FRIENDS OF MILTON CREEK COUNTRY PARK
MILTON CREEK COUNTRY PARK.
PROPOSED 'ROOM' REPLACEMENT.
(BUILDING DETAILS SHEET 1 OF 5)

SCALE	1:50	Date	MAY 2023
DWG No.	MCCP/001/BC1	REV	A

ELEVATIONS (1:50)

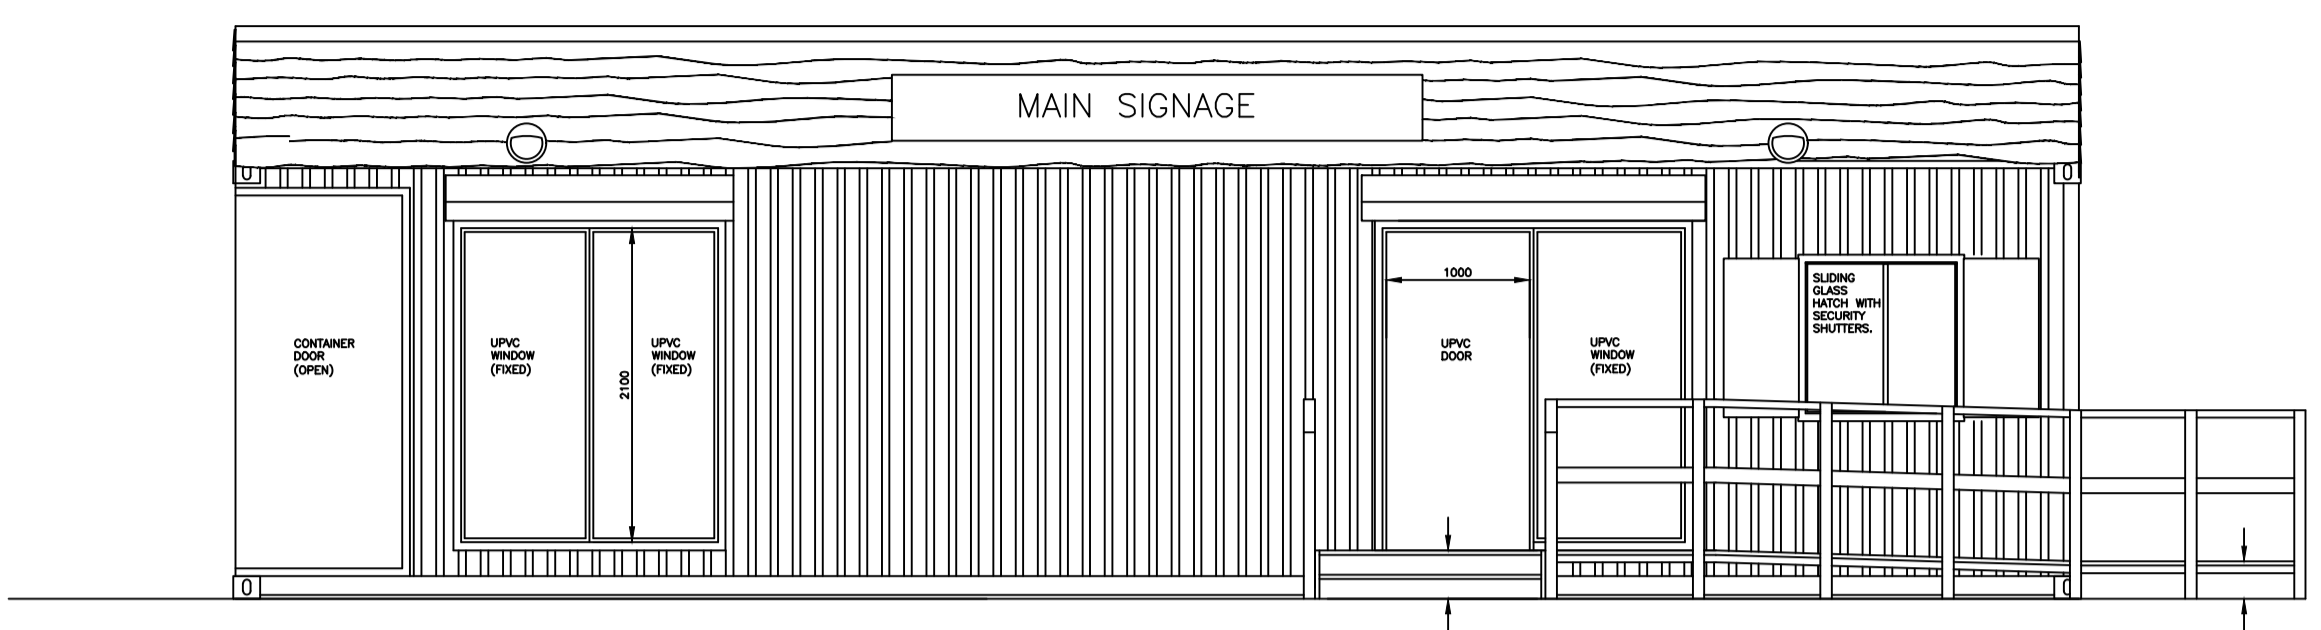
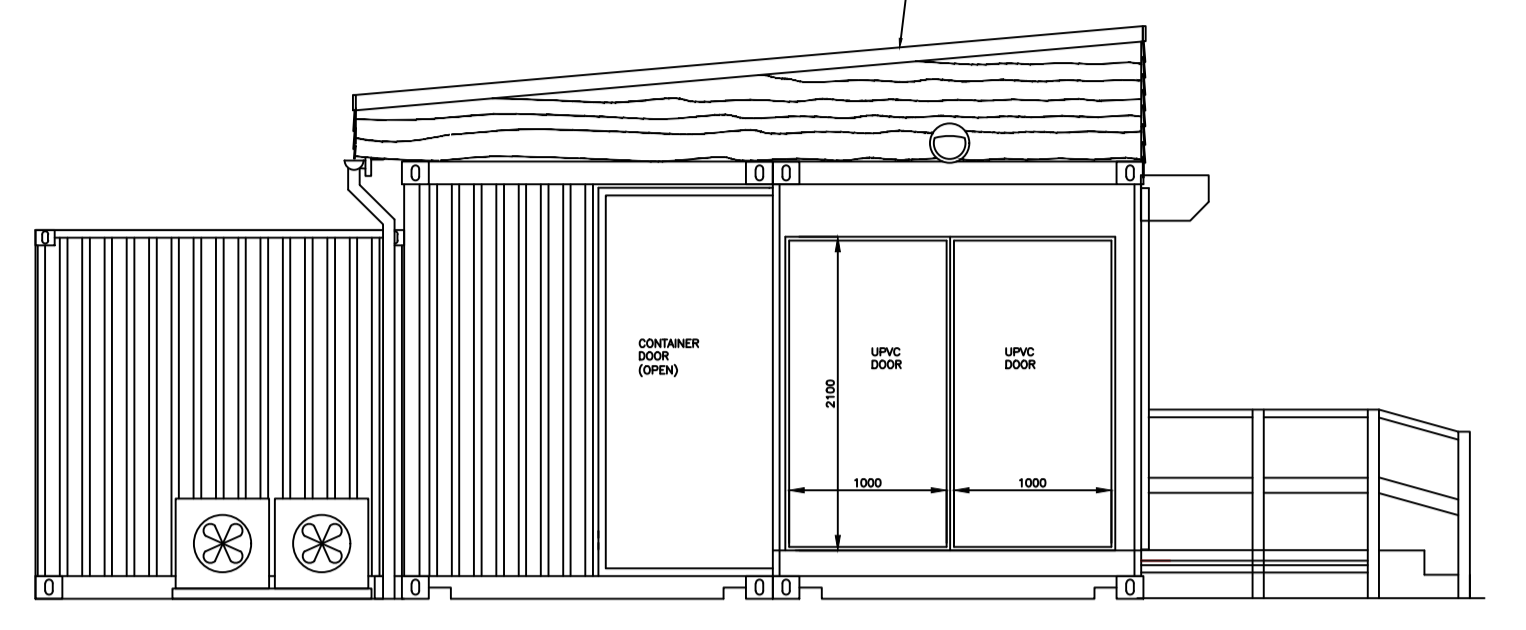
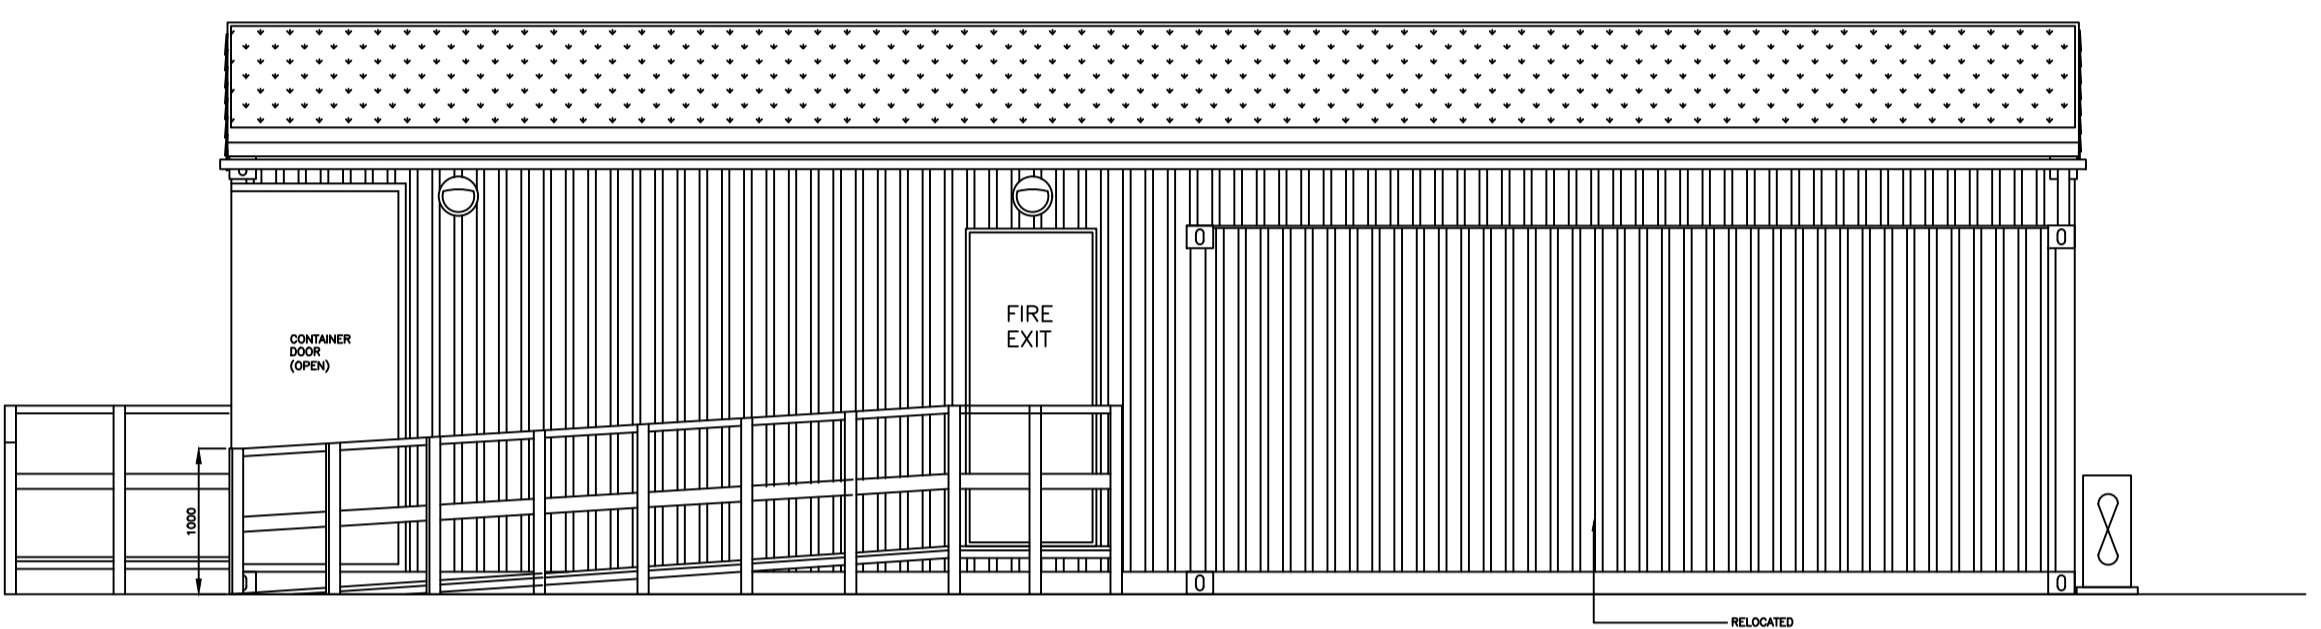
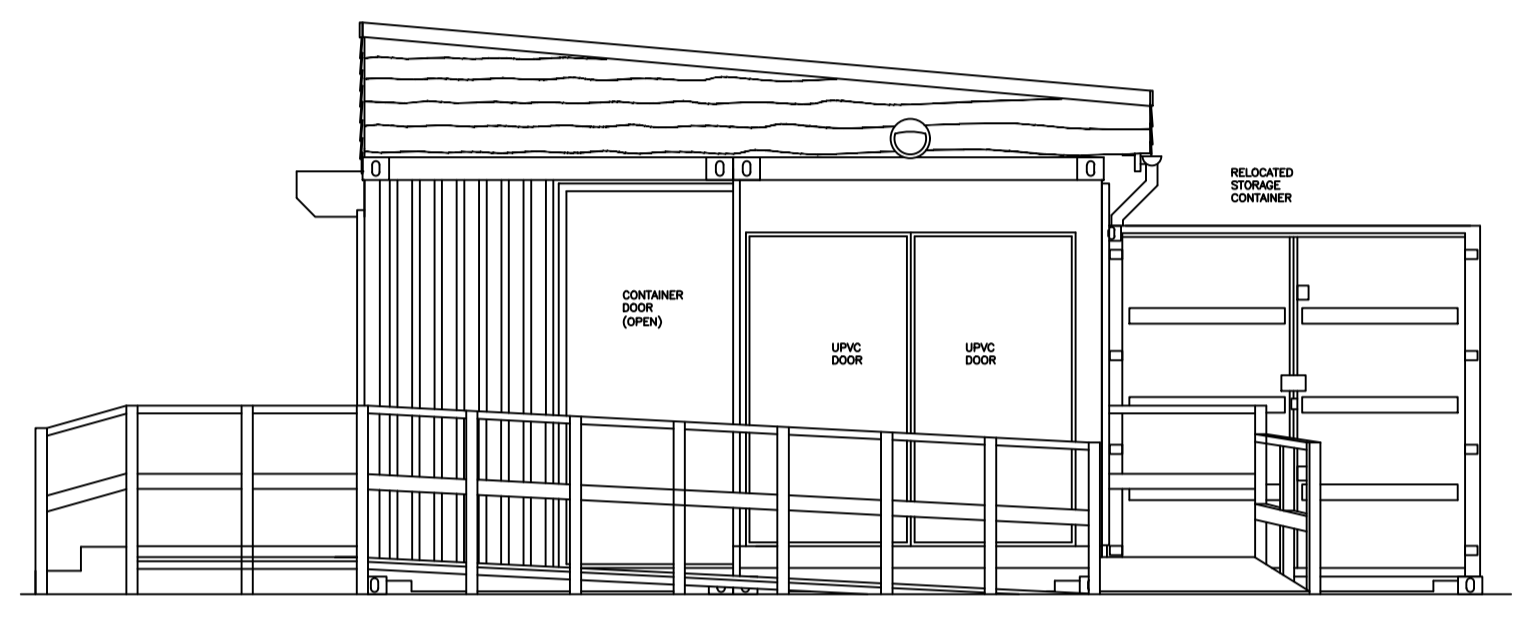
No.	Date	Description
A	Aug 2023	1. PRINCIPLE DOOR LAYOUT AMENDED TO INDICATE OUTWARD OPENING DOOR. 2. HEATING SYSTEM CHANGED TO REVERSIBLE HEAT PUMP. 3. RAINWATER SYSTEM ADDED TO REAR OF ROOF. 4. SHUTTERS TO NORTH FACADE DELETED. 5. ROLLER SECURITY SHUTTERS ADDED TO NORTH FACADE. 6. EXTERNAL RAMPS ADDED. 7. STORAGE CONTAINER RELOCATED TO ALLOW FOR RAMP FROM FIRE EXIT. 8. FOOTING CORNER DETAIL UPDATED. 9. FIRE EXIT DOOR RELOCATED TO ACCOMMODATE EXTERNAL RAMP. 10. INTERNAL WALL LININGS ALTERED TO ACHIEVE CLASS 0 FIRE RATING. 11. SUSPENDED CEILING DETAILS ADDED. 12. EXTERNAL DECORATIVE TIMBER PANELS DELETED.
